ADDENDUM NO. ONE  
GREATER HEIGHTS ACADEMY –  
FOUR CLASSROOM ADDITION  
Page 1 of 1 (write up only)

April 22, 2015

ADDENDUM NO. ONE to the plans and specifications for the GREATER HEIGHTS ACADEMY – FOUR CLASSROOM ADDITION, Flint, MI, Architect's Project No. 141601, dated March 31, 2015.

A01-SK-1

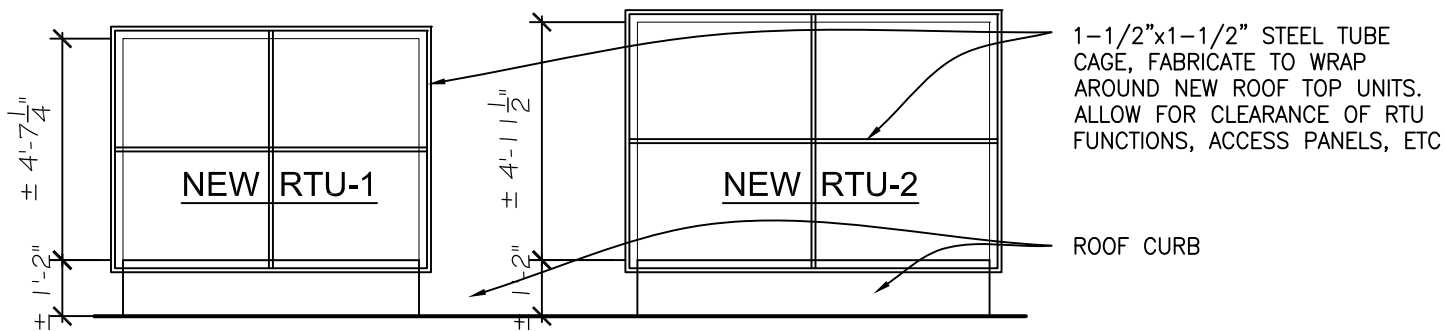
- ITEM NO. A3** Refer to Drawing A1.1 (not reissued), Drawing A6.1 (not reissued) and Sketch A01-SK-1 (issued).
1. Added detail showing upper cabinets, cubbies and coat rack system, per drawing on Sketch A01-SK-1.

A01-SK-2

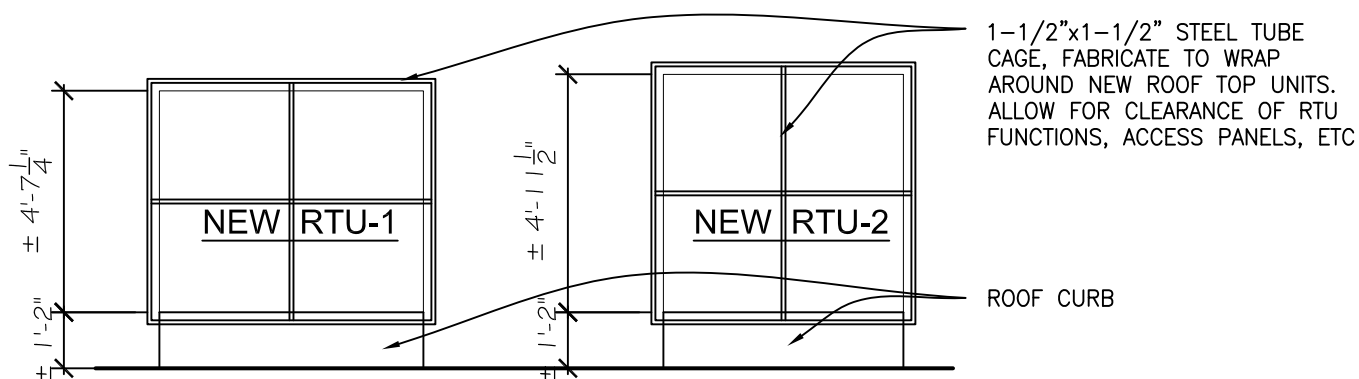
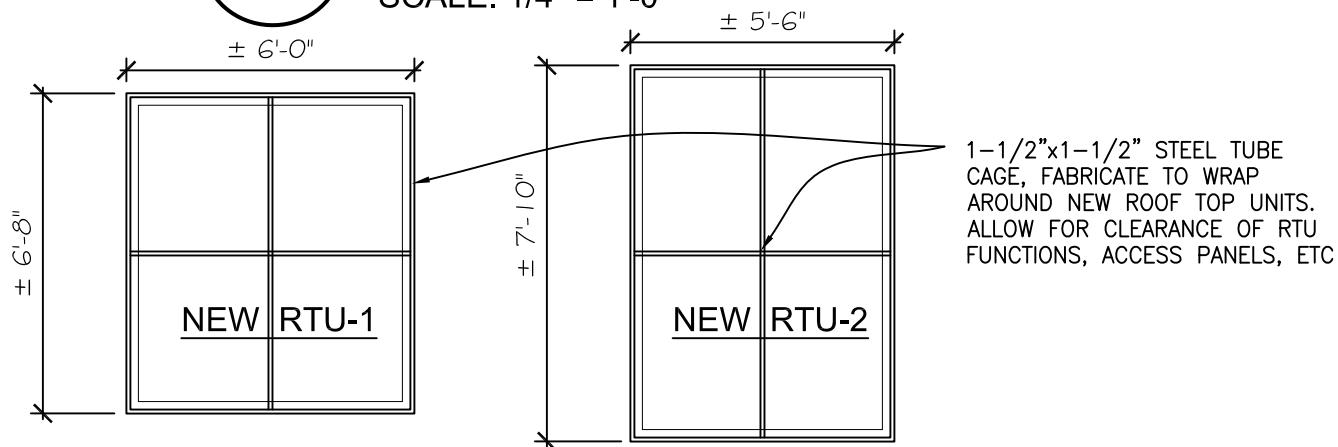
- ITEM NO. A4** Refer to Drawing A2.1 (not reissued) and Sketch A01-SK-2 (issued).
1. Added details showing steel cages around new roof top units, per drawings on Sketch A01-SK-2.

## TYPICAL EAVE DETAIL - NORTH AND SOUTH WALLS

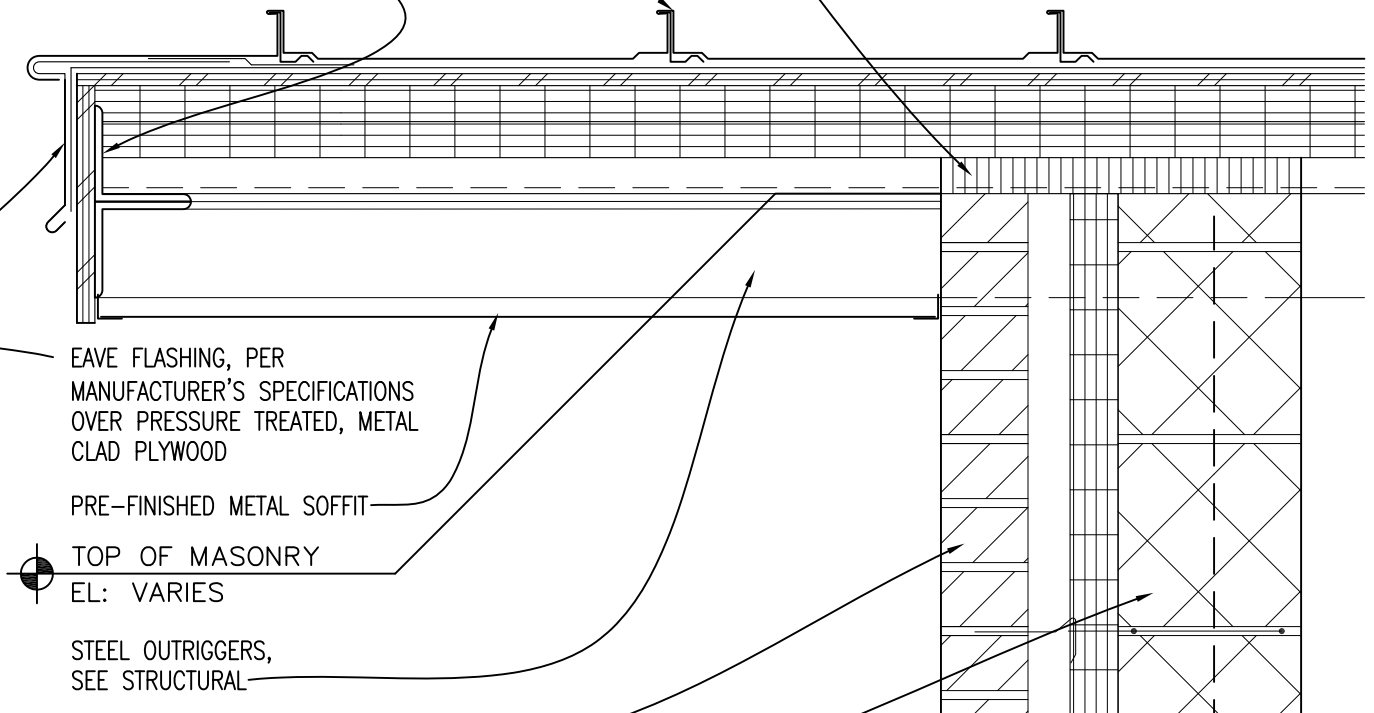
- ITEM NO. A5** Refer to Drawing A4.2 (not reissued) and Sketch A01-SK-3 (issued).
1. Added typical eave detail for North and South wall overhang eave condition, per drawing on Sketch A01-SK-3.

A01-SK-4

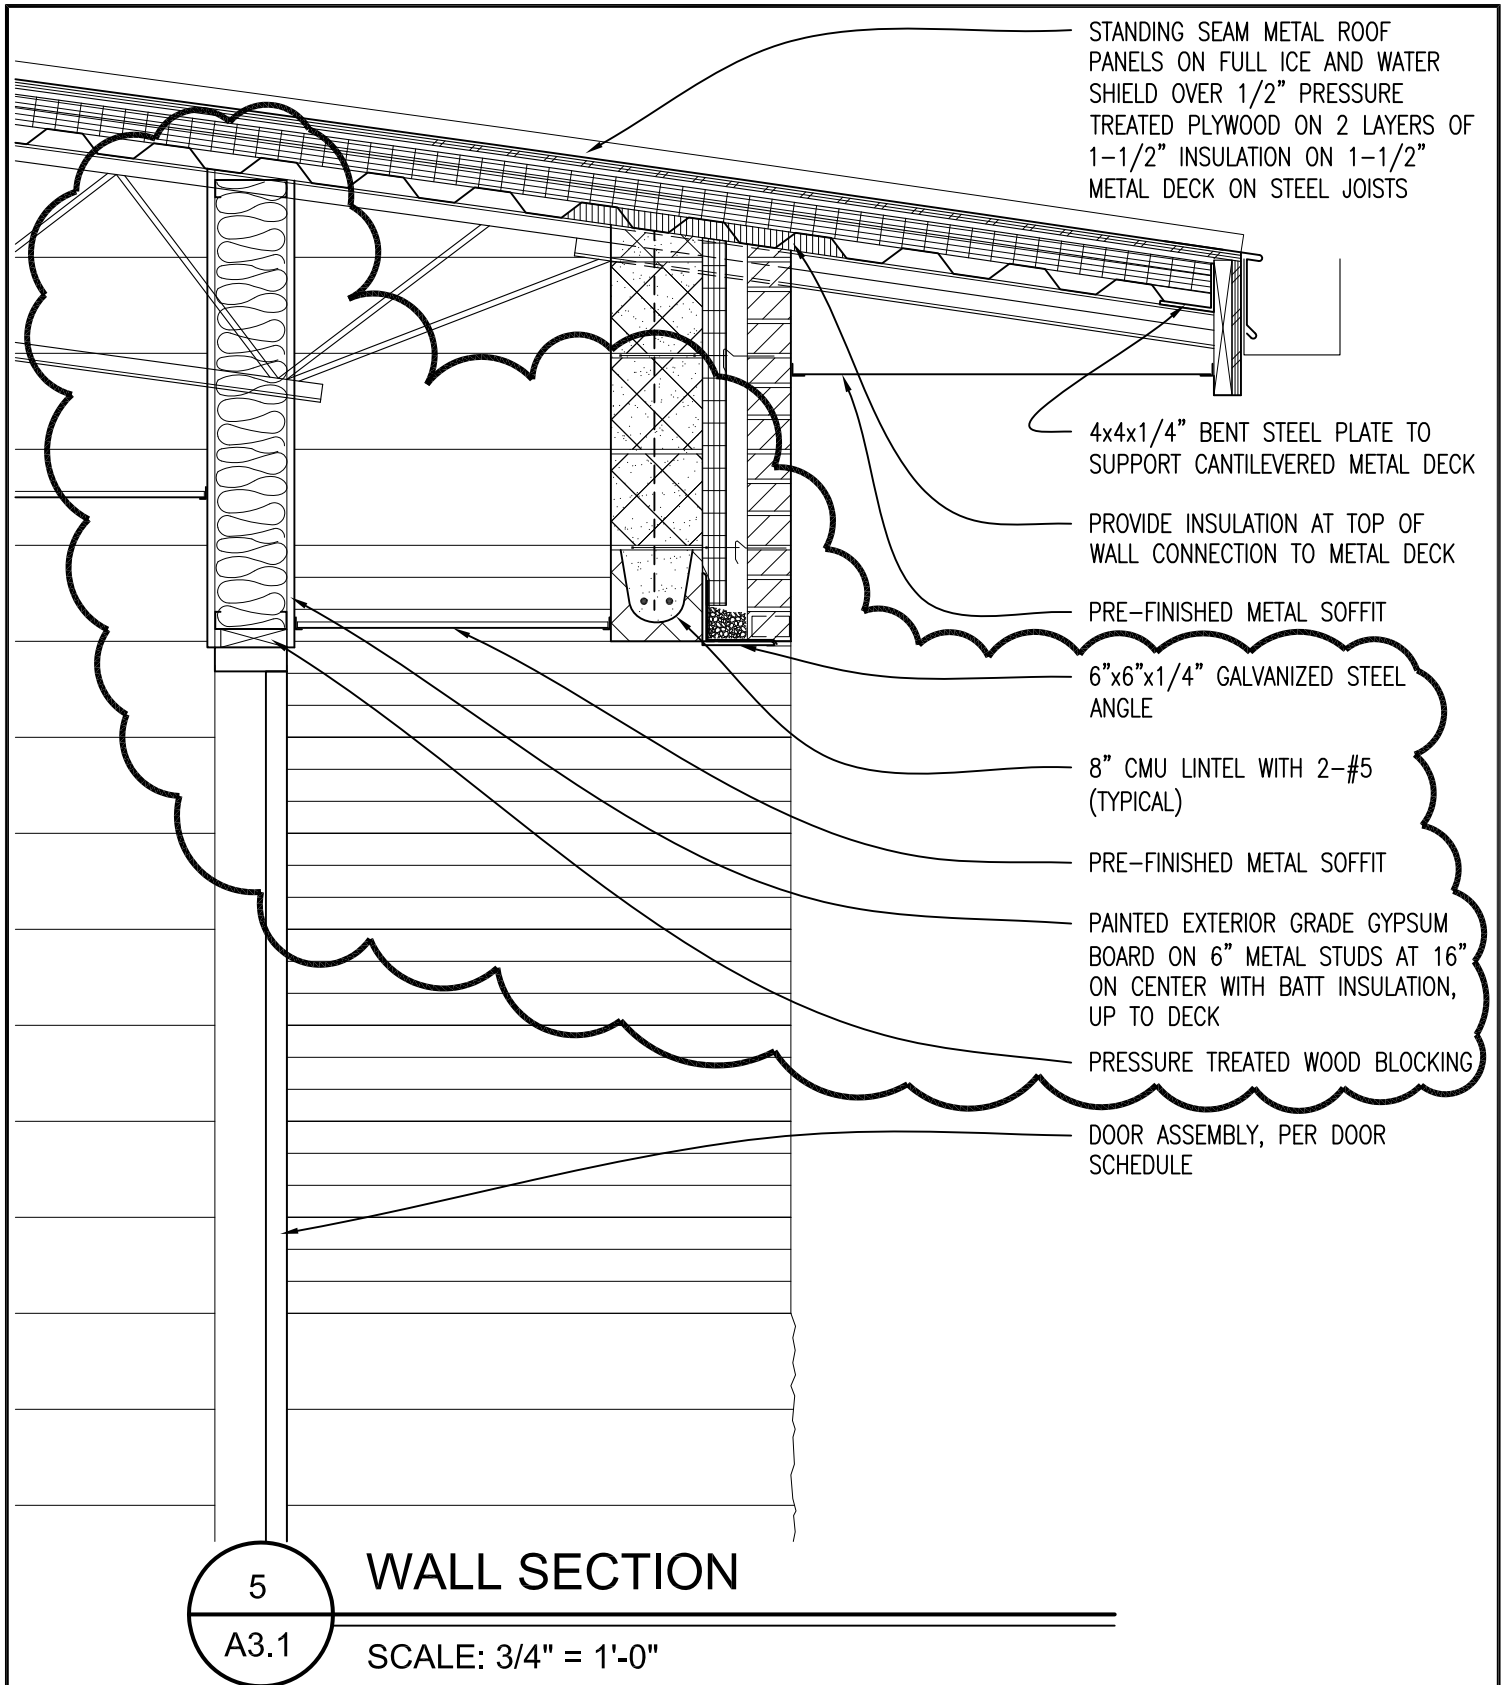
1. Wall Section 1: Added typical eave detail for East wall overhang eave condition, per drawing on Sketch A01-SK-4.
  2. Wall Section 1: Revised CMU bond beam and steel lintel, at top of wall, per drawing on Sketch A01-SK-8.

A01-SK-5

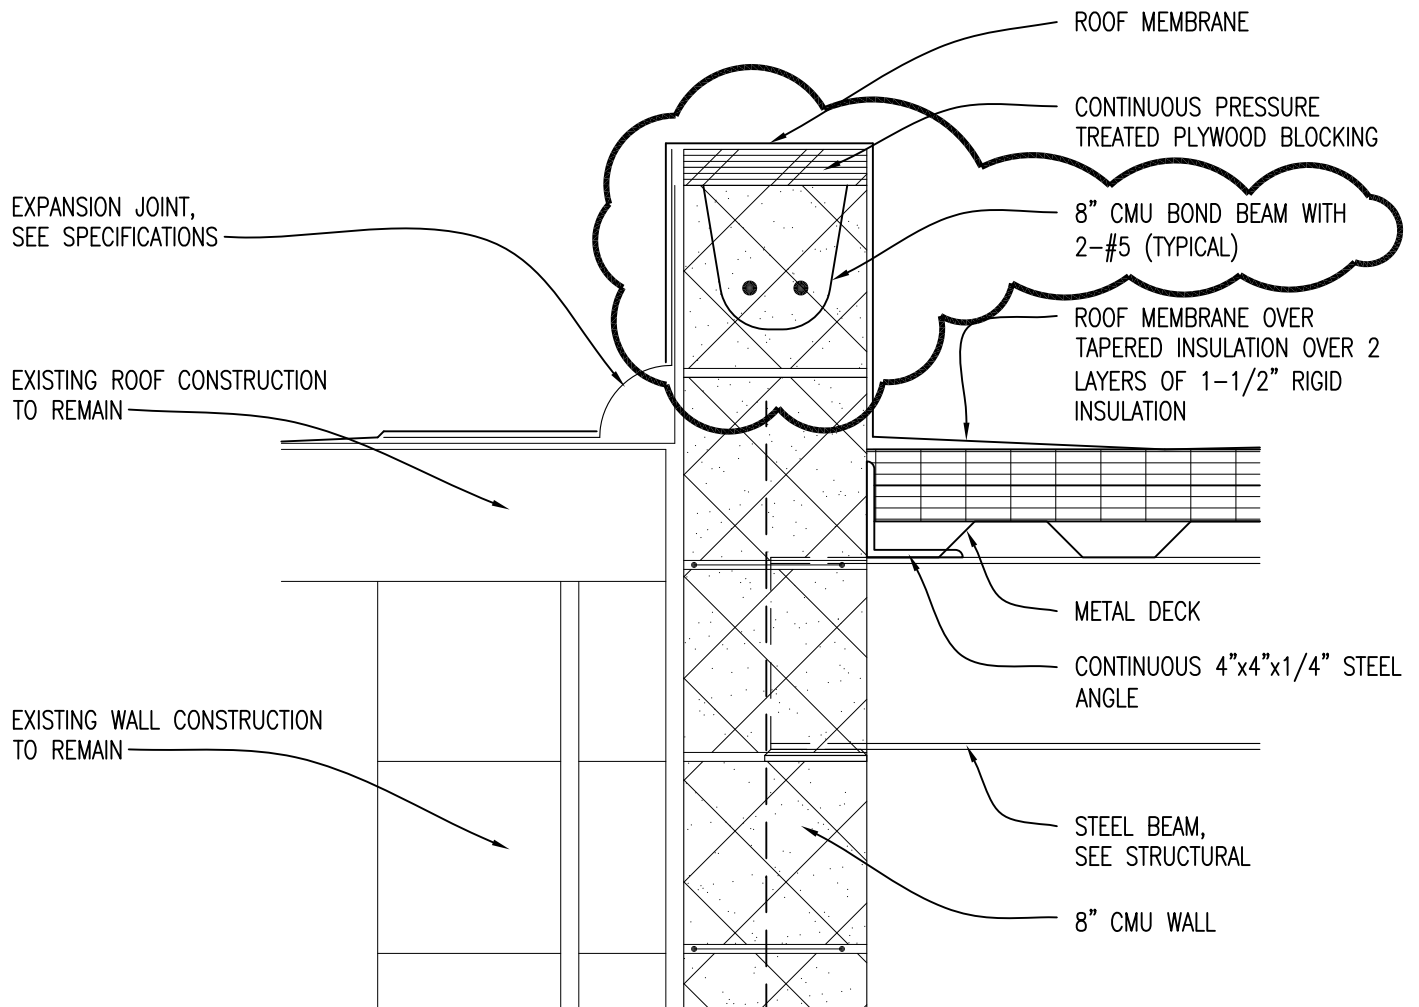
Refer to Drawing S1.1 (issued), Sketch A01-SK-4 and Sketch A01-SK-5 (issued).

A01-SK-6

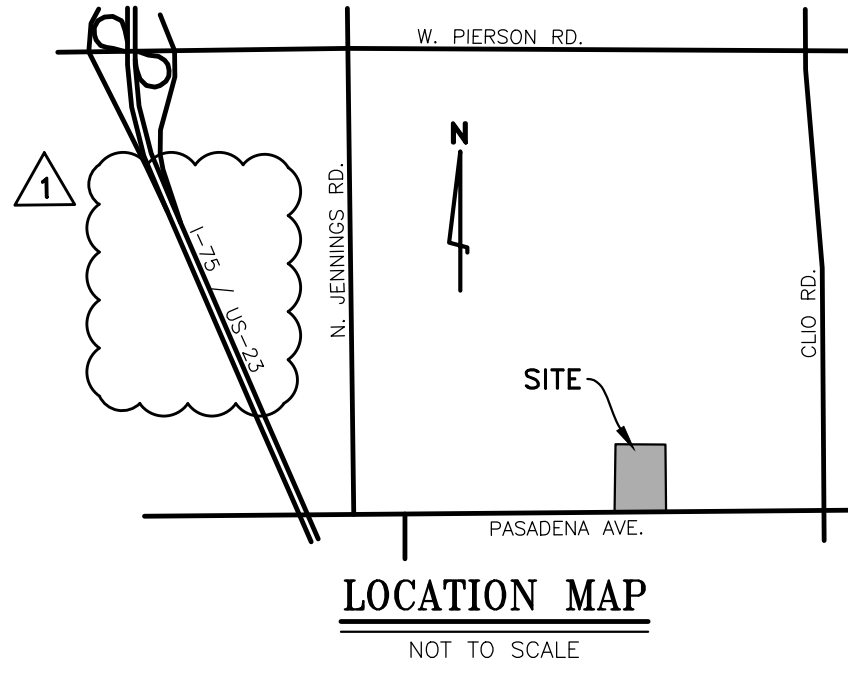
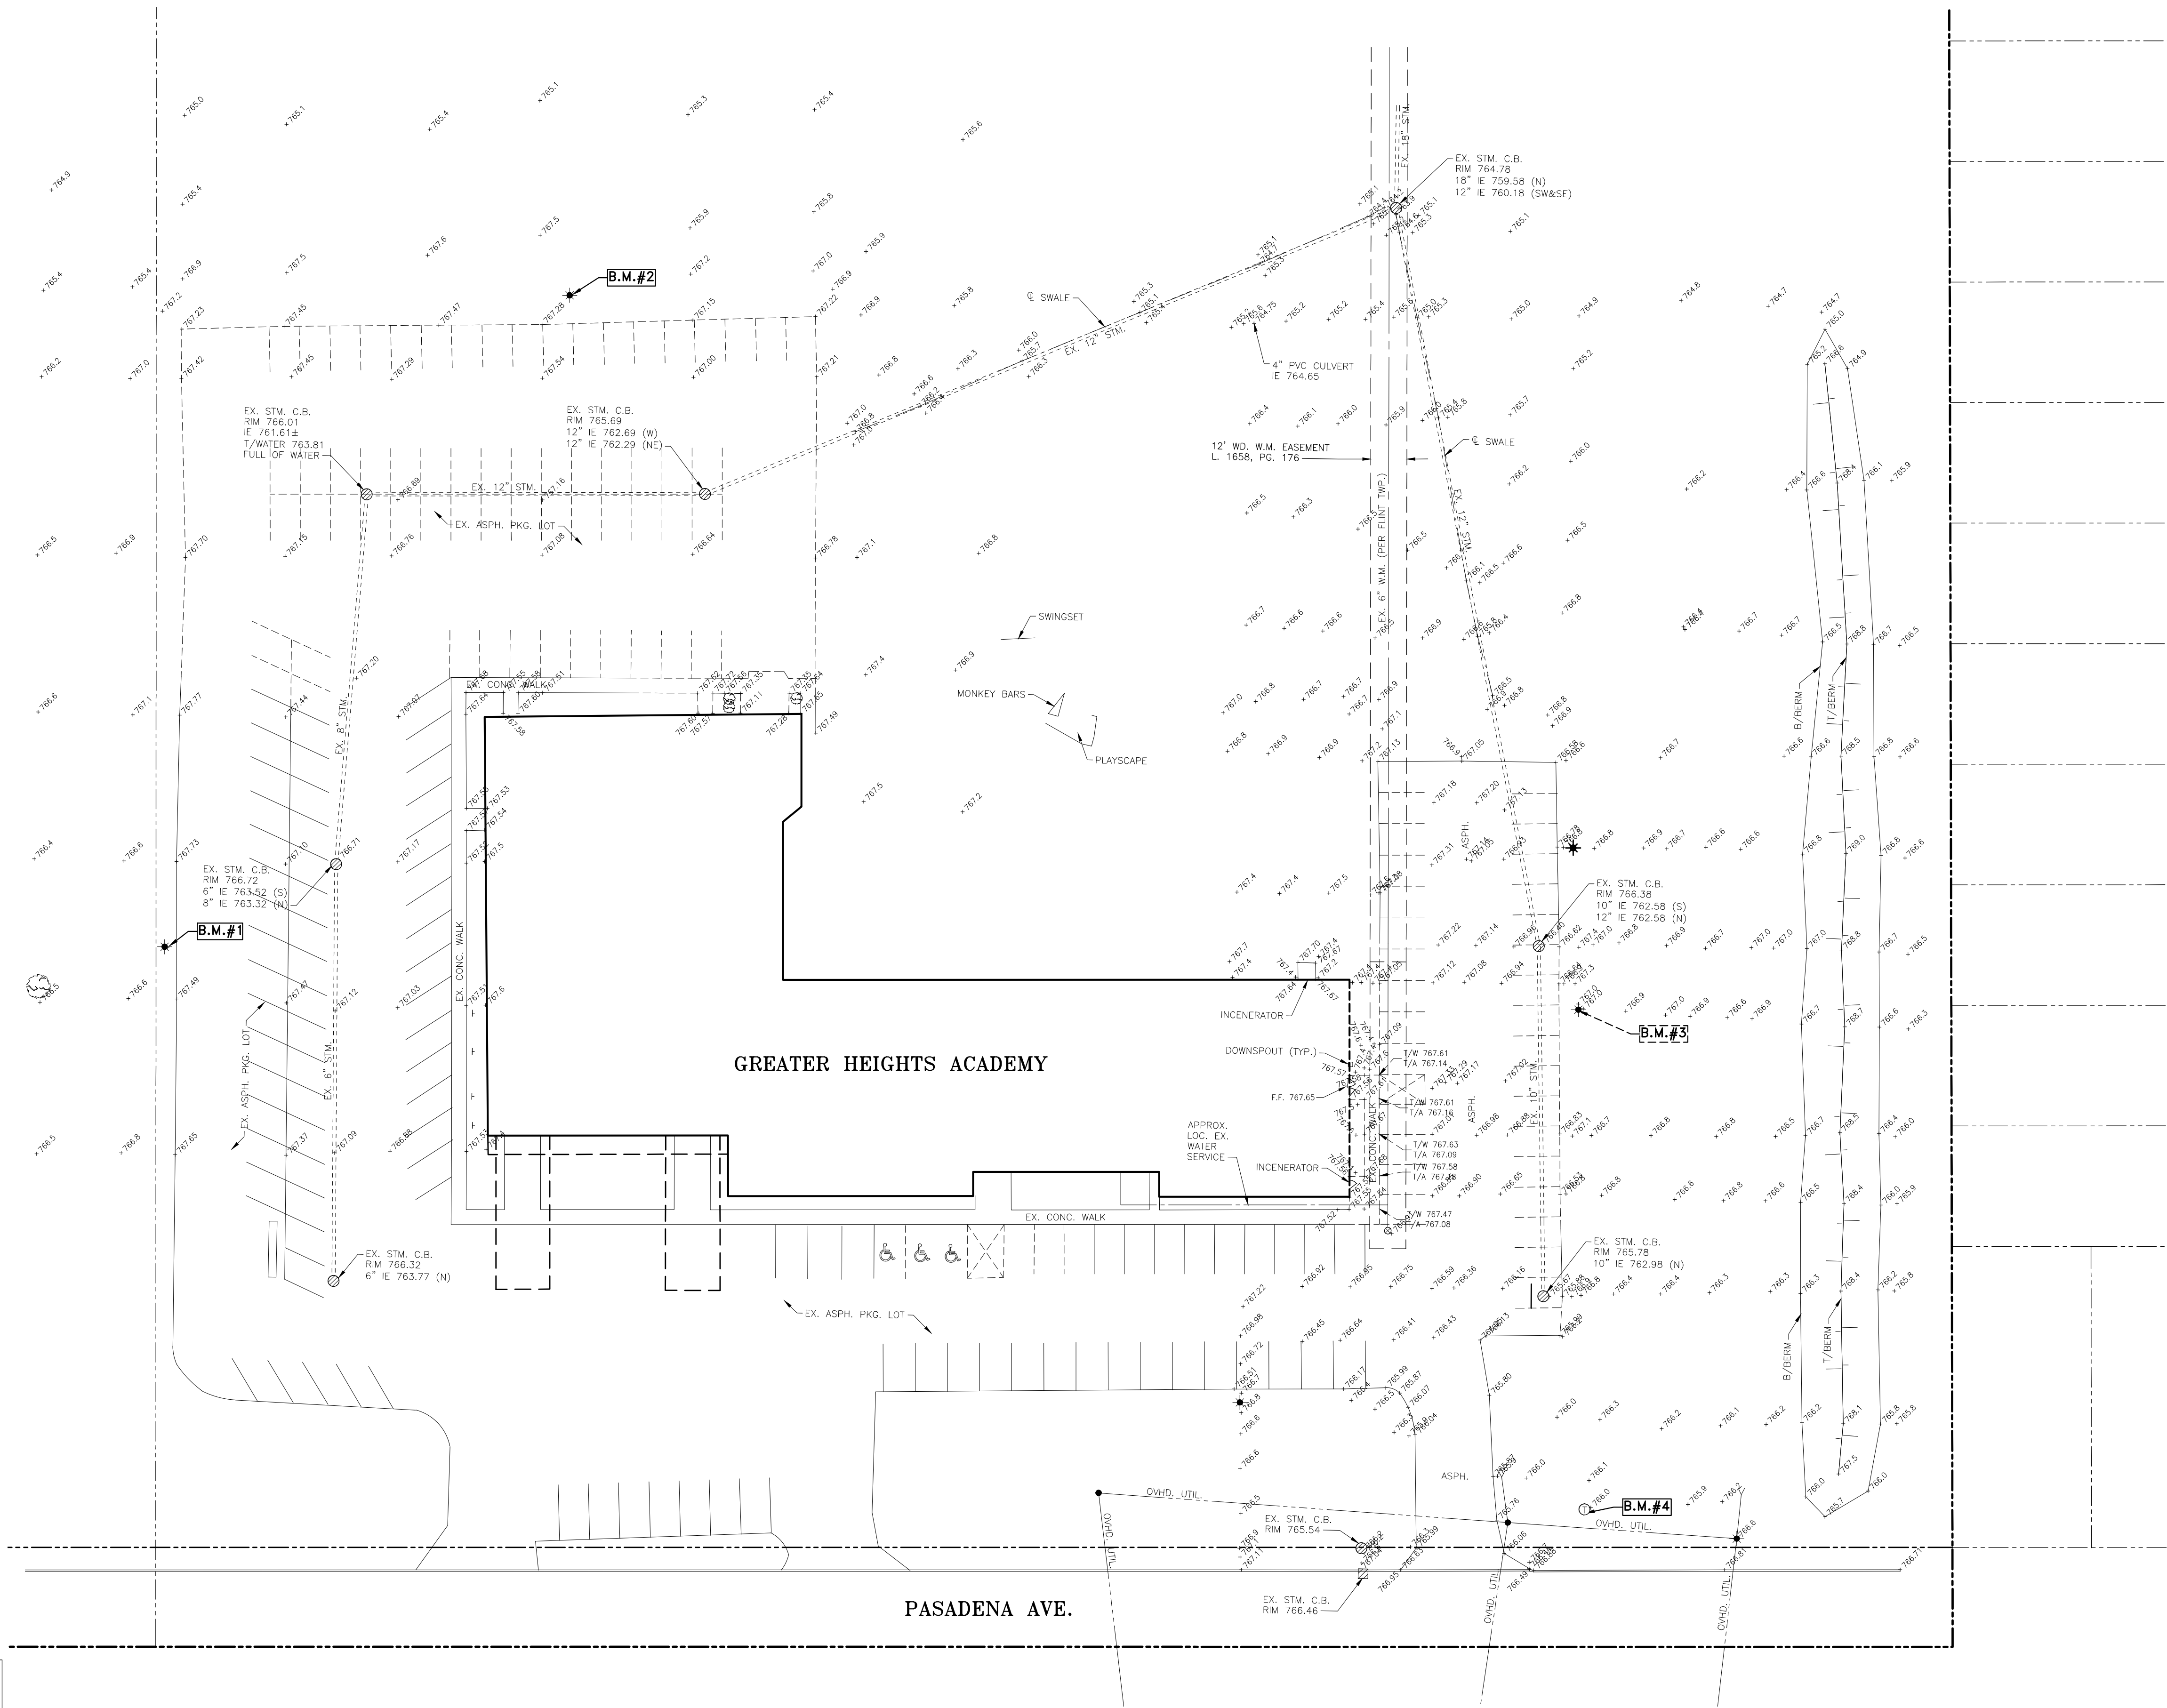
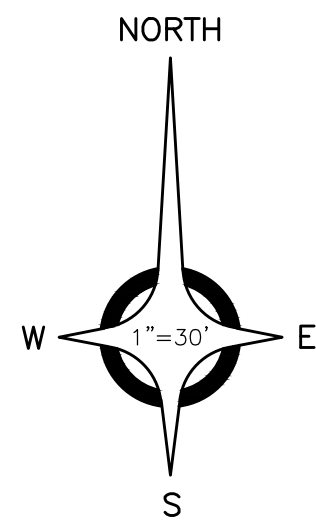
3. Wall Section 4: Added 8" cmu bond beam at top of wall, per drawing on Sketch A01-SK-6.
  4. Wall Section 2: Added 8" cmu bond beam at top of wall, per drawing on Sketch A01-SK-7.
